RESOLUTION SETTING HEARING ON CITY-INITIATED REQUEST TO REZONE AND ON REQUEST FROM CASEY'S FOR APPROVAL OF PUD CONCEPTUAL PLAN FOR PROPERTY LOCATED 3200 AND 3212 SOUTHWEST 9TH STREET AND 930 PARK AVENUE

STAFF REPORT TO THE PLANNING COMMISSION

CONCEPTUAL PLAN CASEY'S GENERAL STORE

SHEET
2 OF 4

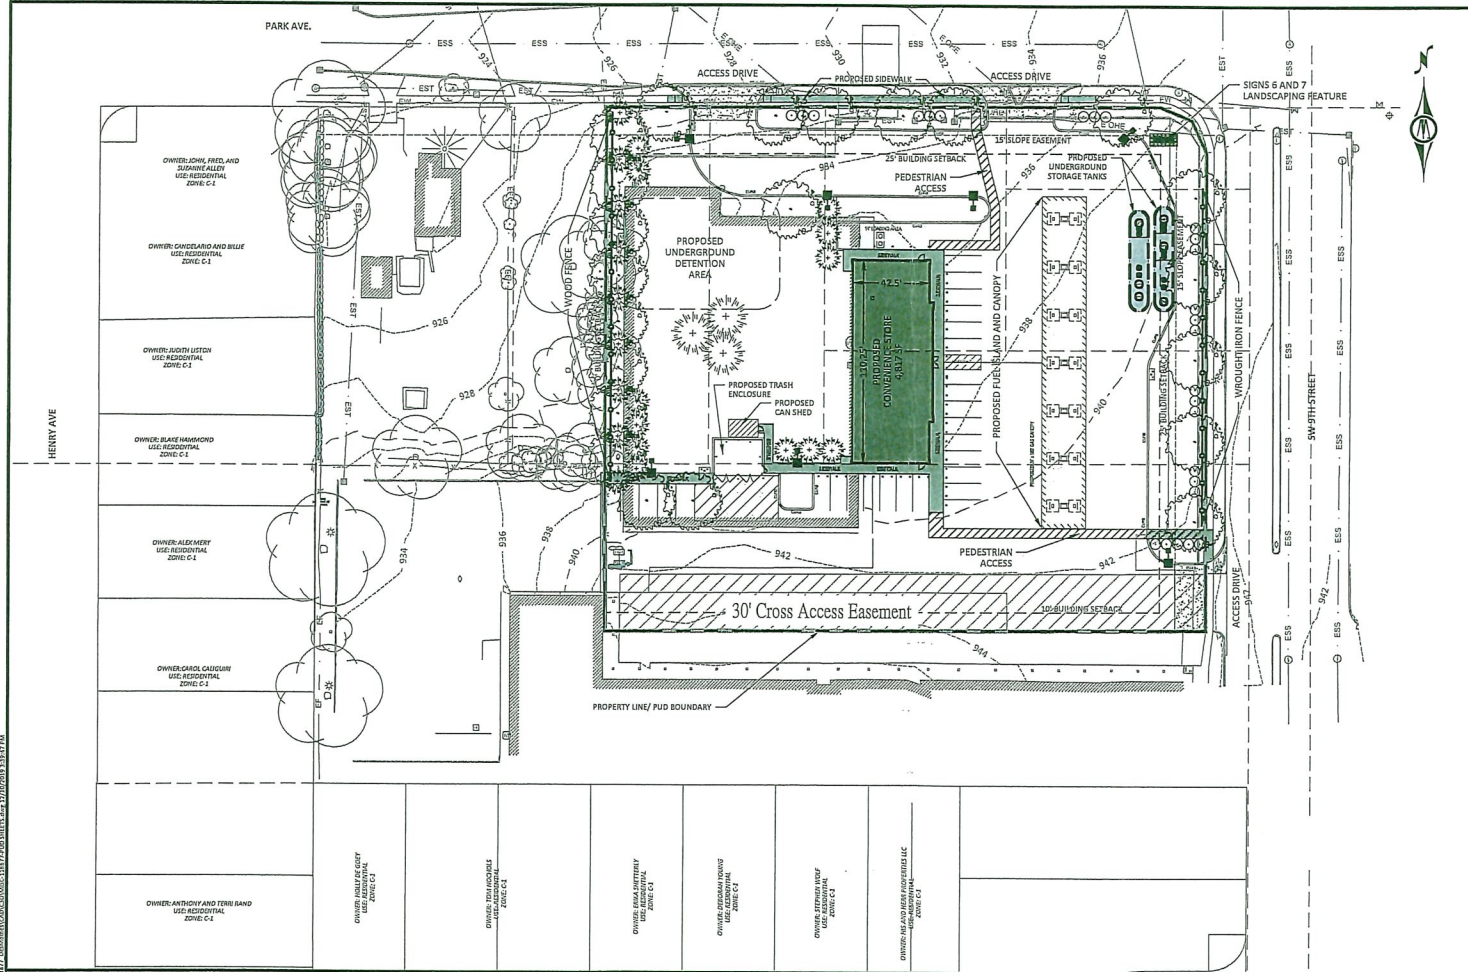
5. Provision of Class A sidewalks along both public streets with street tree planters.
6. Provision of decorative iron type fencing in the perimeter lot landscaped area along both Southwest 9th Street and Park Avenue.

7. Provision of bicycle racks and outdoor seating areas within the sidewalk area in front of the building. This may require the building to be shifted to the west slightly to accommodate a wider sidewalk in front of the store.

A stormwater detention basin is shown on the Conceptual Plan in the western portion of the site. There is public storm sewer available in Park Avenue at the northwest corner of the site and in Southwest 9th Street at the northeast corner of the site.

There are not overhead transmission lines along the street frontage. However there are over head service connections to electrical transmission lines across the street or in front of adjoining property. Staff believes all new electrical services and all existing street light services for lights abutting the building should be placed underground as part of any PUD Development Plan as a requirement of the Conceptual Plan.

Staff believes that because the property is located in a Neighborhood Node in PlanDSM it is intended to provide more pedestrian intensity, Therefore, the streetscape on both sides should be a Class A sidewalk with tree planter beds and decorative fencing between the sidewalk and interior paved area. This will give the edges of the site a more pedestrian scale.

Monument Sign (4 Product)									
Sign #	Sign	Type	Location	Illumination	Dimensions				Area Ft ²
					Bottom	Top	Width	Height	
6	House Logo	Freestanding	Street	Internal	7' 3"	13' 0"	7' 7-1/2"	5' 9"	36.3
7	Price Sign	Freestanding	Street	Internal	1' 9"	7' 8"	7' 7-1/2"	5' 6"	41.94
Total									78.24

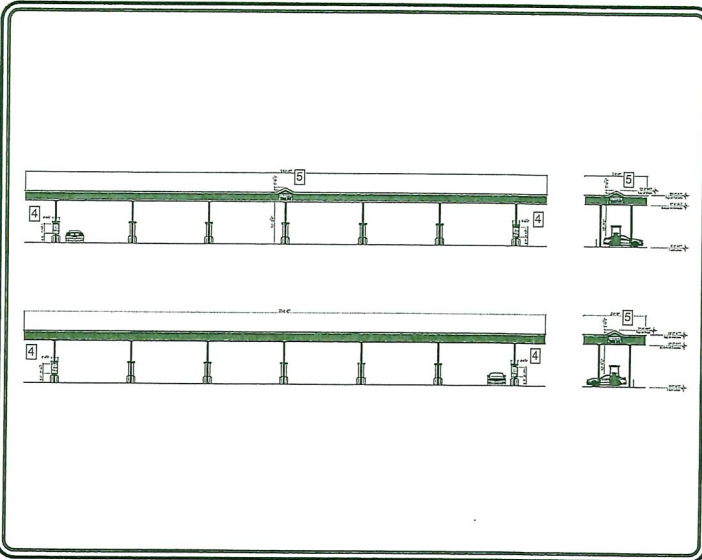
3. Revision of the proposed monument sign to comply with the “FSO” Freestanding Signs Overlay District provisions.
4. Addition of a note indicating that existing overhead electrical utility service lines will be placed underground as part of any PUD Development Plan.

The submitted Conceptual Plan includes a monument style sign. The sign would be 13 feet tall with a 1-foot 9-inch tall brick base. The City has adopted the "FSO" Freestanding Sign Overlay District and amended the monument sign design requirements. Below are the relevant portions of Section 134-1276 and Section 134-3 of the Zoning Ordinance.

4 Pump Island Canopy - (Street Side)
1/8" = 1'-0"

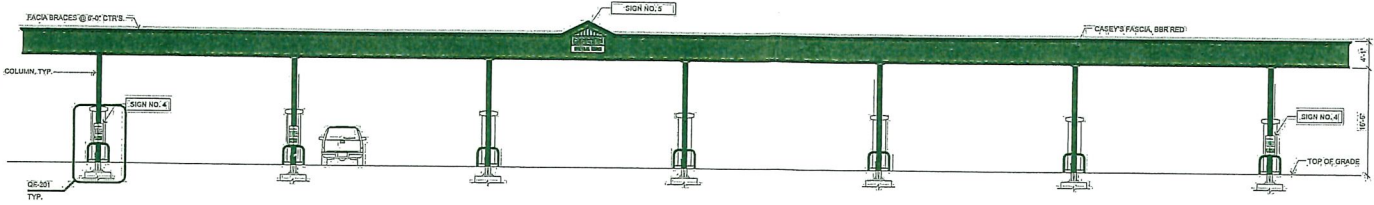
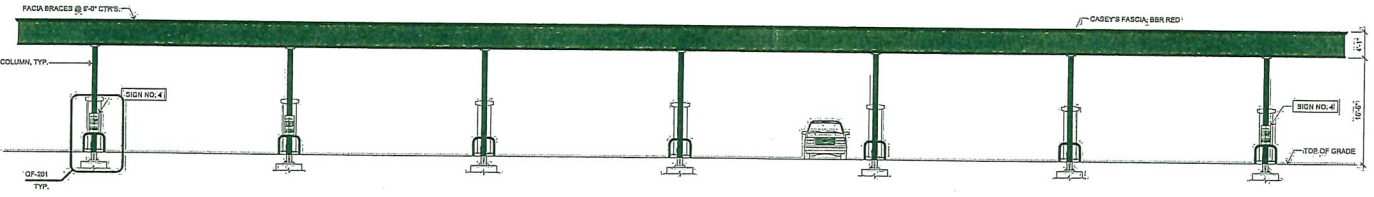
1. Reduction of the canopy height for the major portion of the canopy to 18 feet maximum. This would exclude any articulation feature that is designed to break up the expanse of the canopy length.

2. Provision of at least one articulation in the canopy to break the long expanse and cladding of the support columns in brick to match the building, to the satisfaction of the Planning Administrator.

The proposed fuel pump island canopy would be sided with metal and supported by metal columns. Staff believes that these should be clad with brick to match the building. There needs to be an articulation in the canopy to break up the long linear pump array that is proposed. Staff recommends a canopy design similar to the Casey's Store at 63rd Street and Grand Avenue. The applicant is in the process of submitting a revised canopy concept that would be similar to that location in terms of the articulation but would also provide the brick wrapped columns.

The previously submitted information indicates the total canopy height would be approximately 20 feet 7-inches. The height of the underside of the canopy would 16.5 feet. In this location the site is relatively flat. Therefore, staff believes these maximum heights can be stepped down to meet this standard and still provide enough flexibility for grades. The applicant is submitting a revised design with a center articulation that would exceed the maximum height. However, the overall height of the remaining portion of the canopy should be kept under the 18 foot maximum.

CANOPY: CANOPY HEIGHT SHALL PROVIDE A MINIMUM OF 13'-9" FOR VEHICLE CLEARANCE. A LEVEL STRUCTURE AND ANY DIFFERENTIATION IN HEIGHT SHALL BE INCIDENTAL TO THE FINAL PROPOSED GRADE NECESSARY FOR SITE DRAINAGE. THE CANOPY SHALL BE ARTICULATED WITH VARYING HEIGHTS. CANOPY SHALL BE CLAD WITH BRICK TO MATCH THE BUILDING.
